Addendum 2

To: Megan Finch, Beaverton School District
From: Allison Miller
Project: BSD – Raleigh Park HVAC and Electrical Upgrades
YGH Job #19-0012
Subject: Addendum 2
Date: 23-March-2020

Drawing No.
E3.01

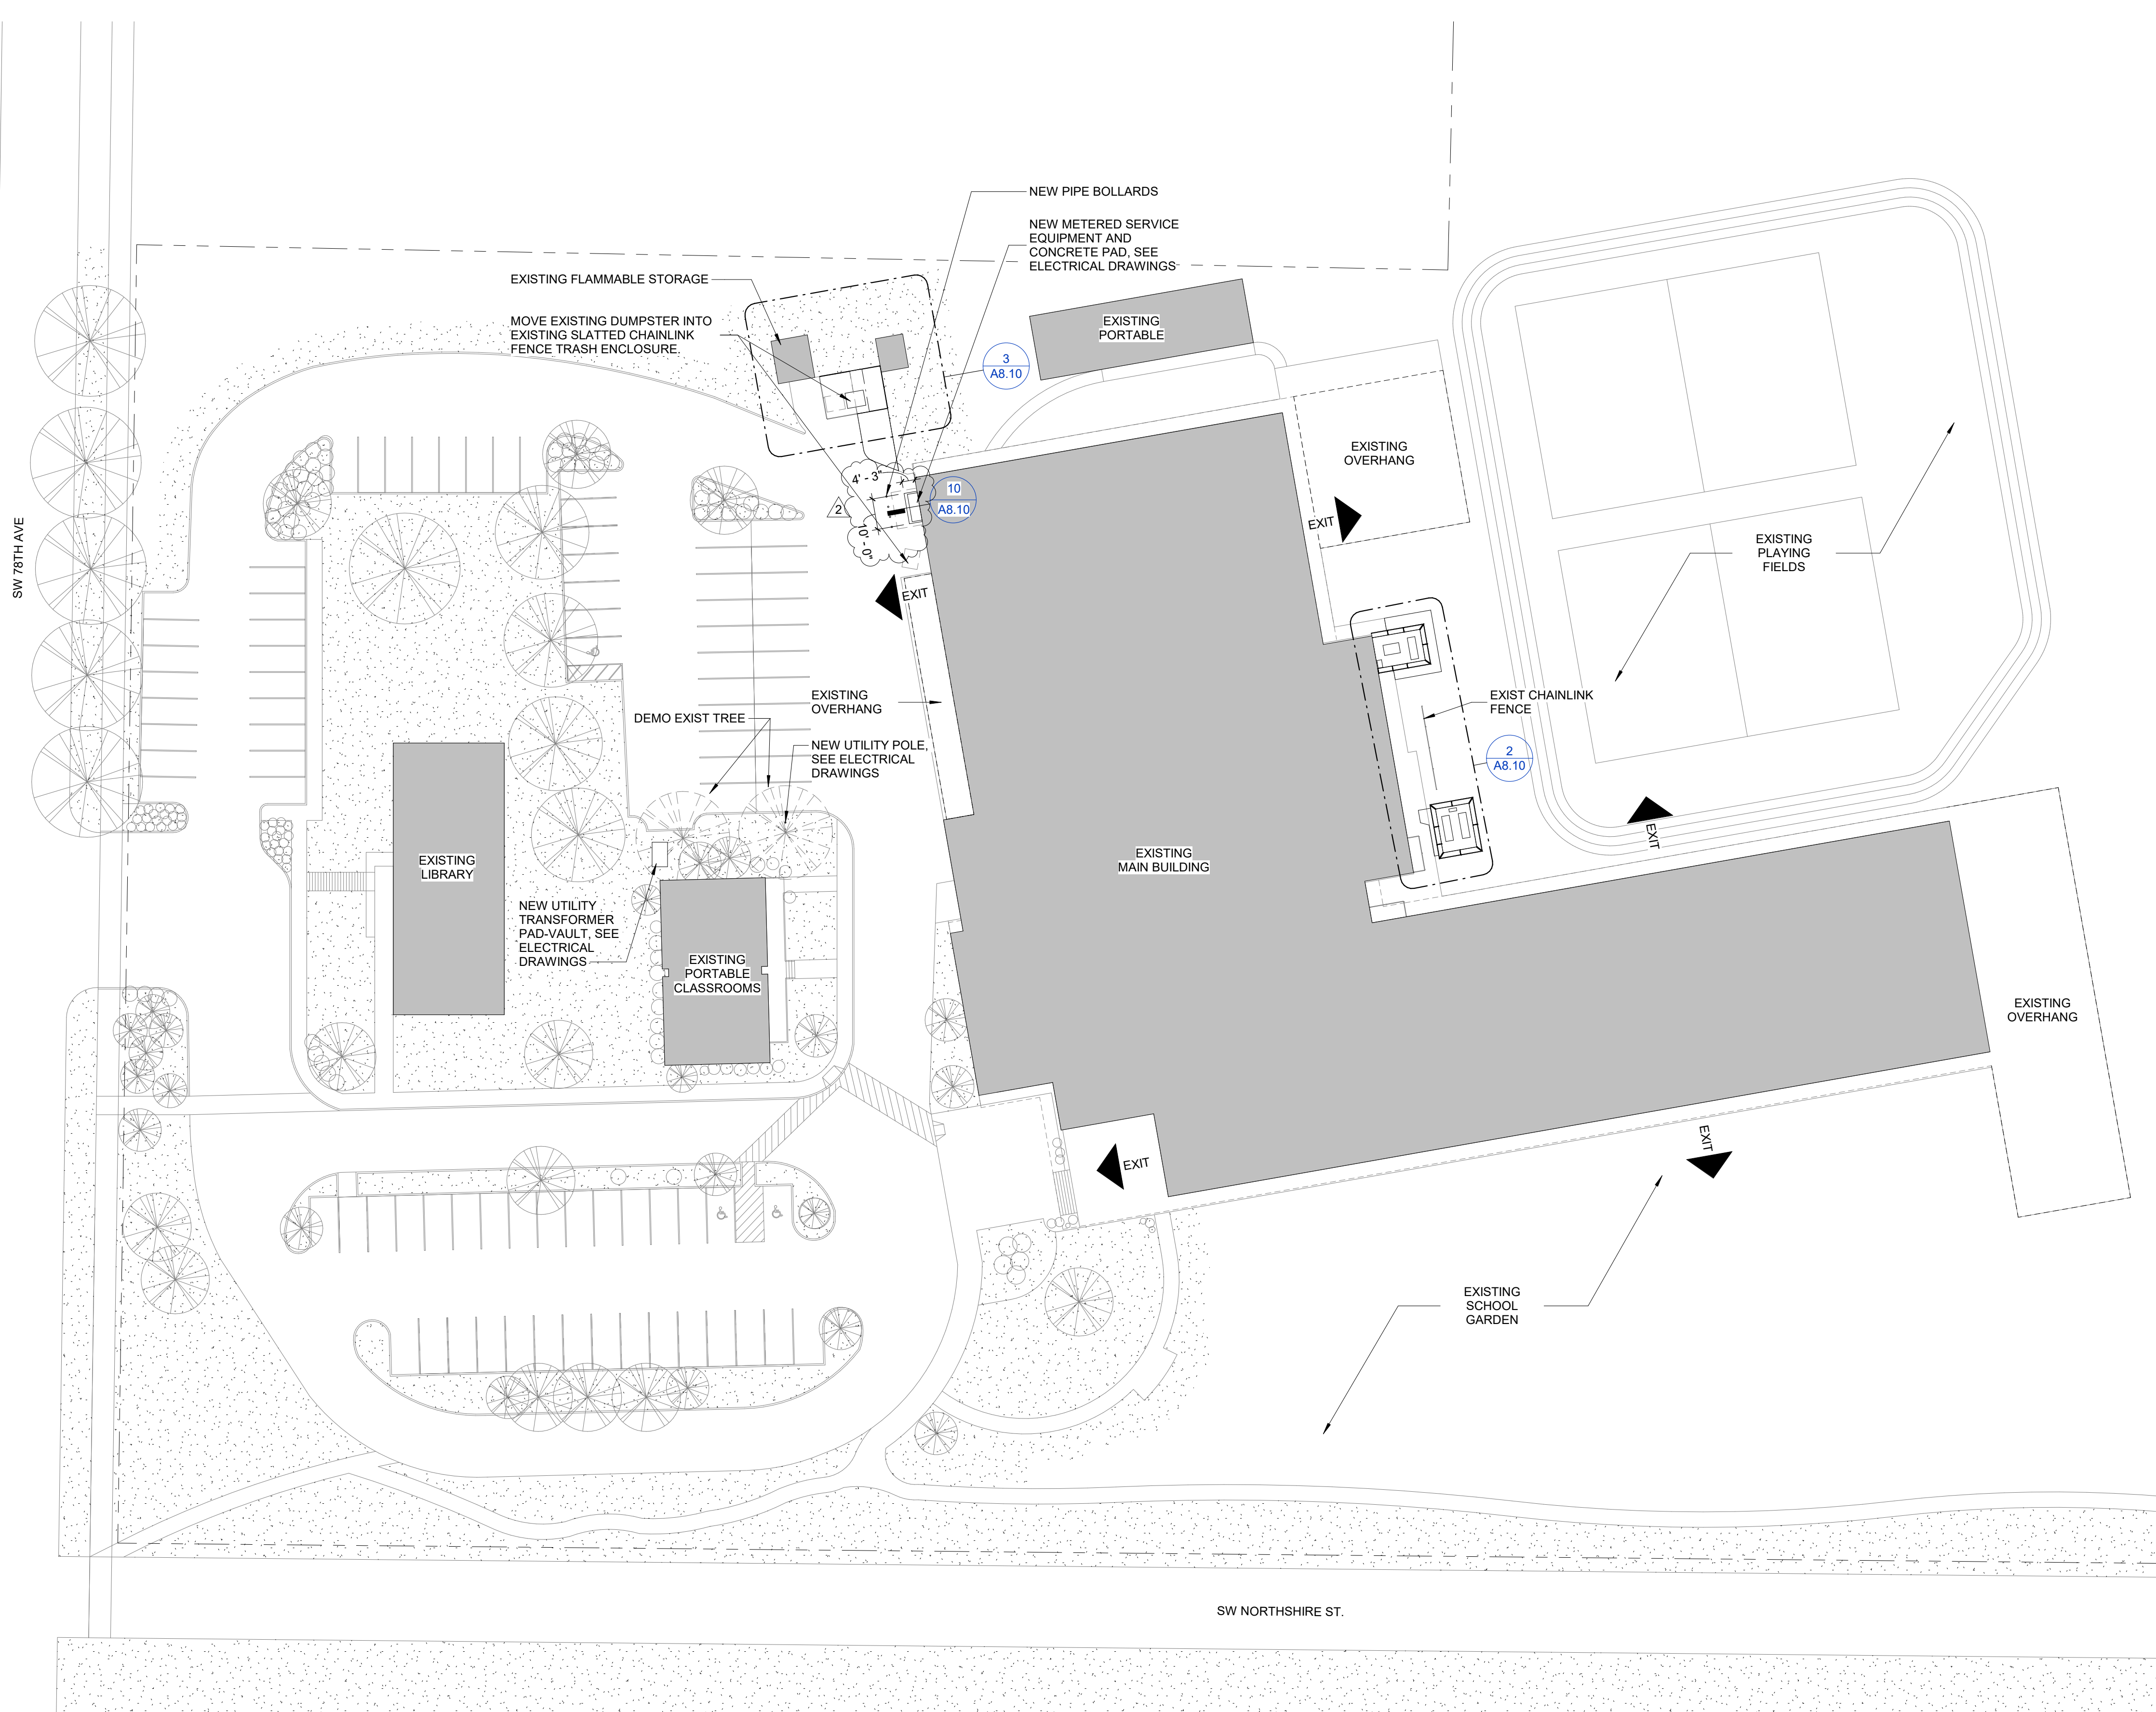
SHEET E3.01 – ELECTRICAL ONE-LINE DIAGRAM

REVISE distribution panel “2MDP” SCCR value to 42,000A in lieu of 65,000A.

REVISE distribution panel “2SDP” SCCR value to 25,000A in lieu of 42,000A.

Drawing No.
A1.01

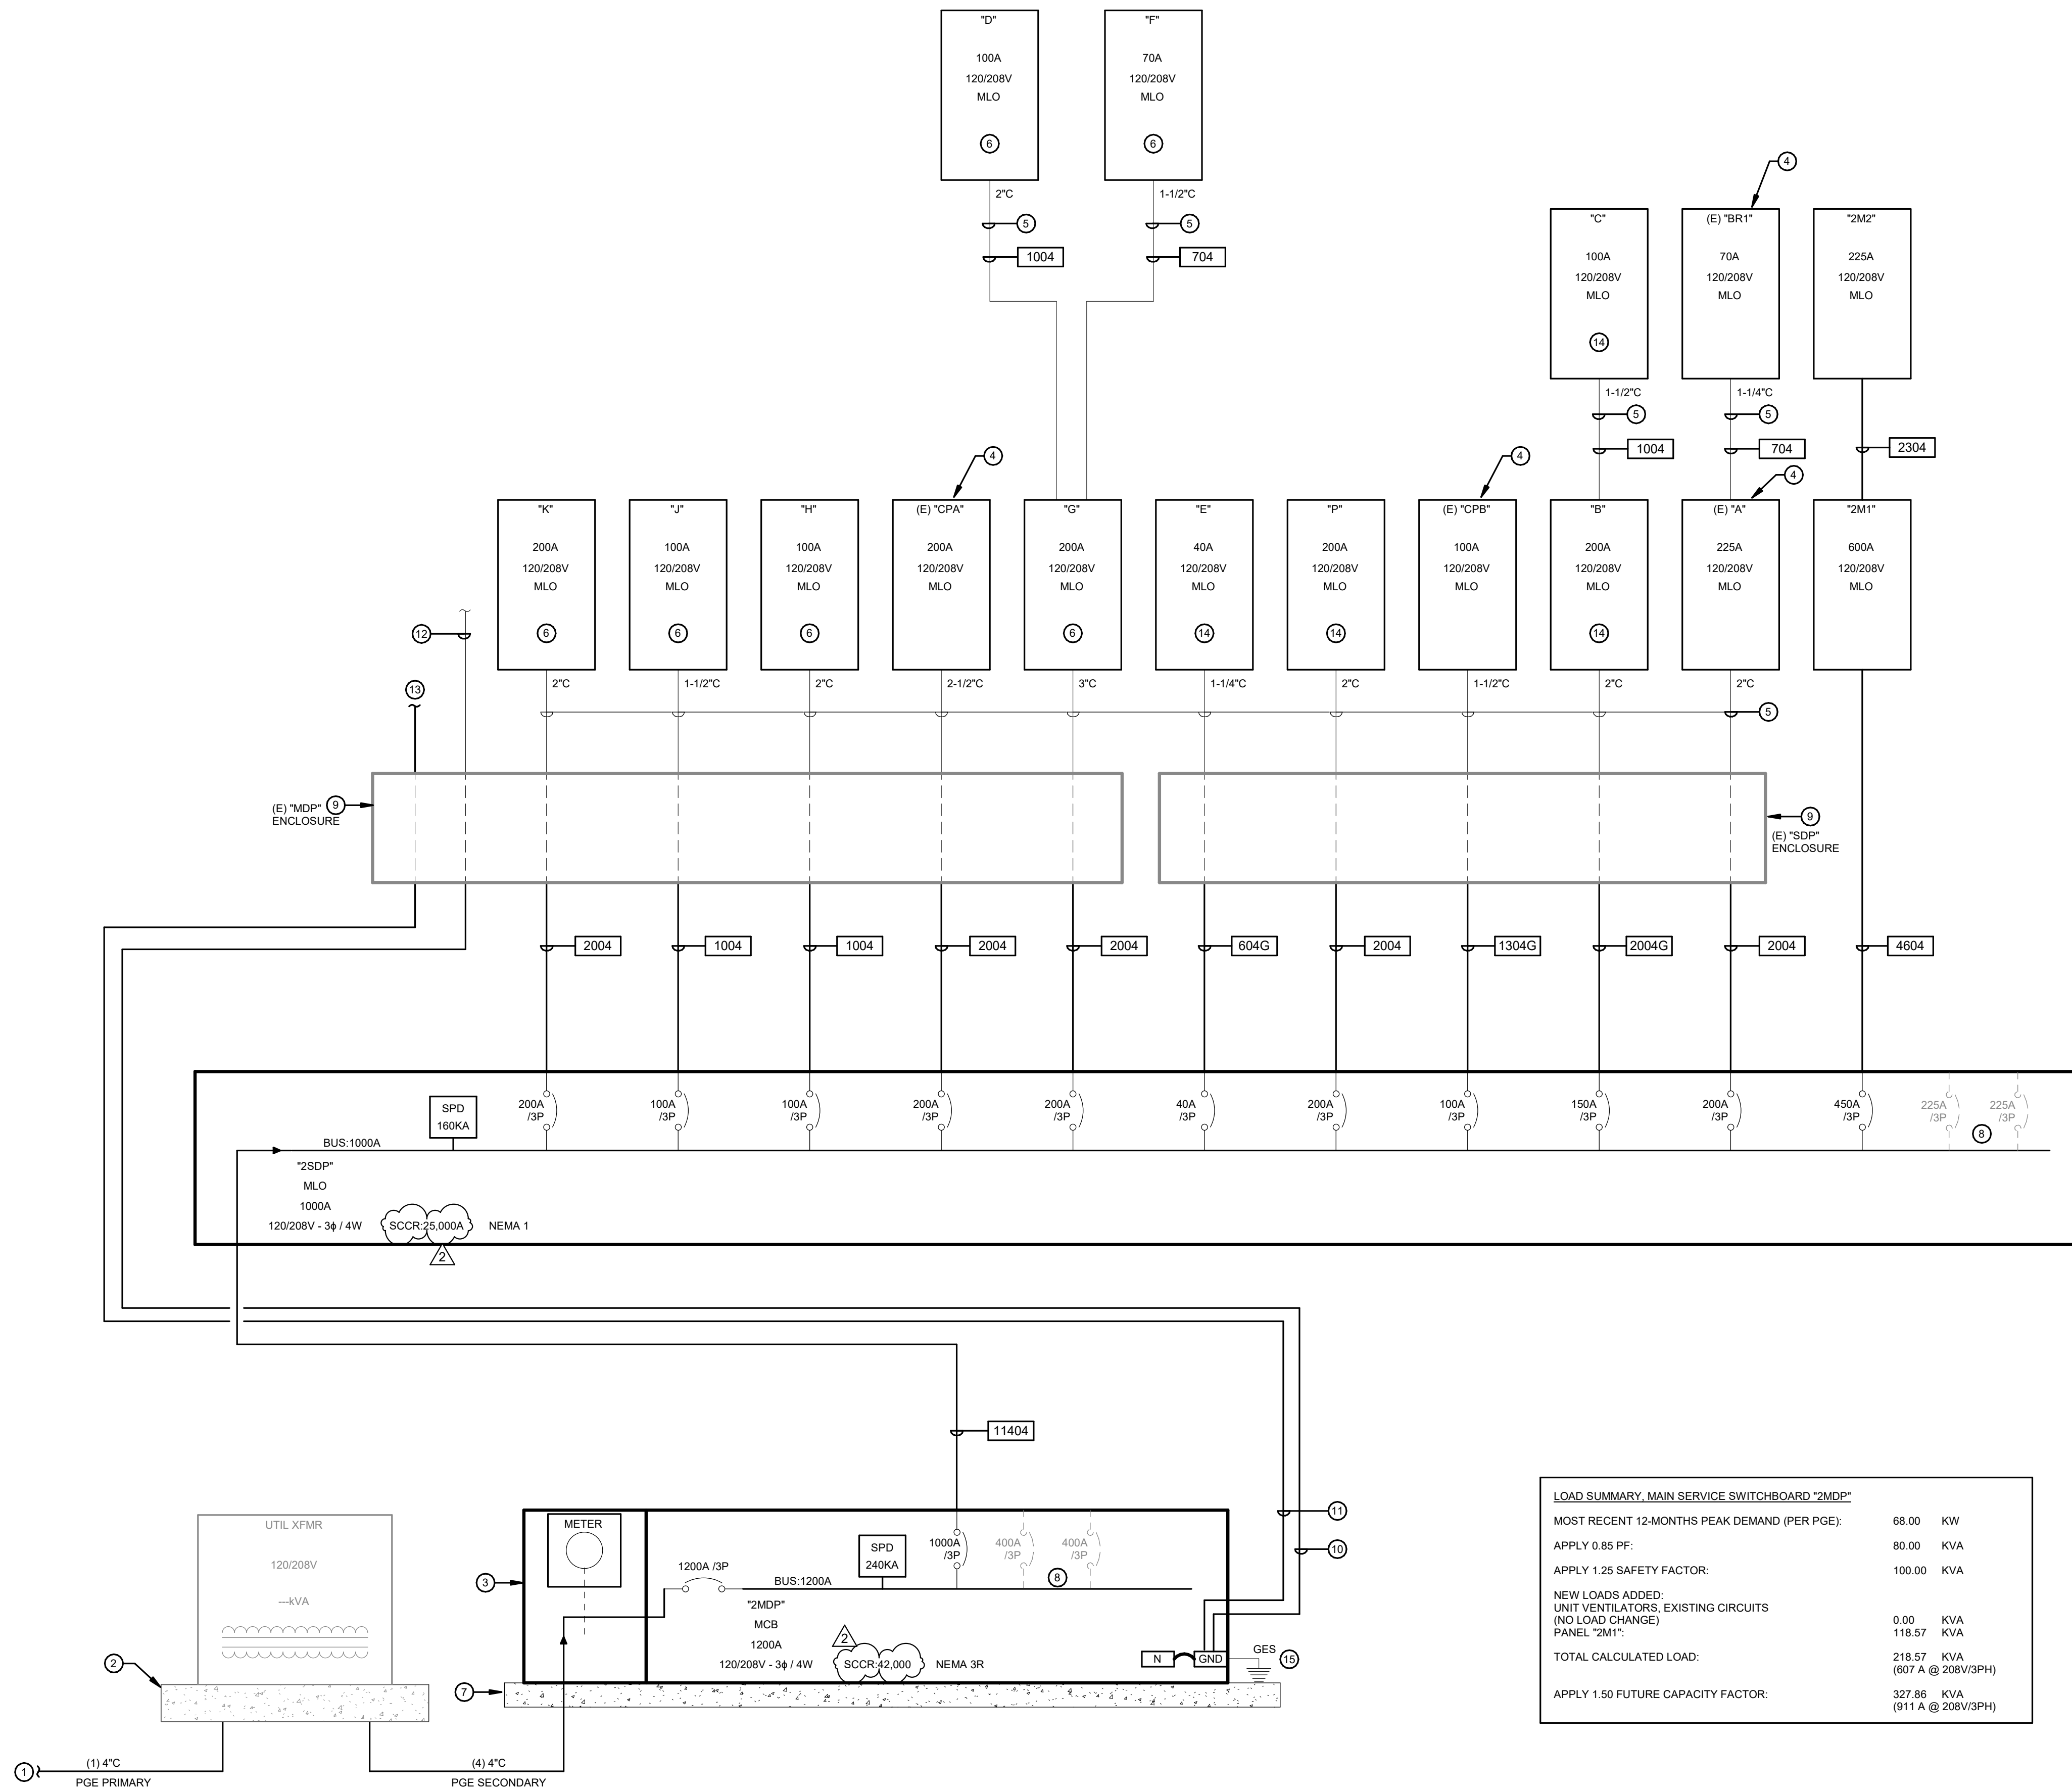
SHEET A1.01 – SITE PLAN

ADD dimensions to new metered service equipment pad

Detail 2 on Drawing S1.01. What is the length and width of the “New Metered Service Equipment Pad?

We will provide dimensions for the new metered service equipment pad on A1.01 in the bid addendum 2.
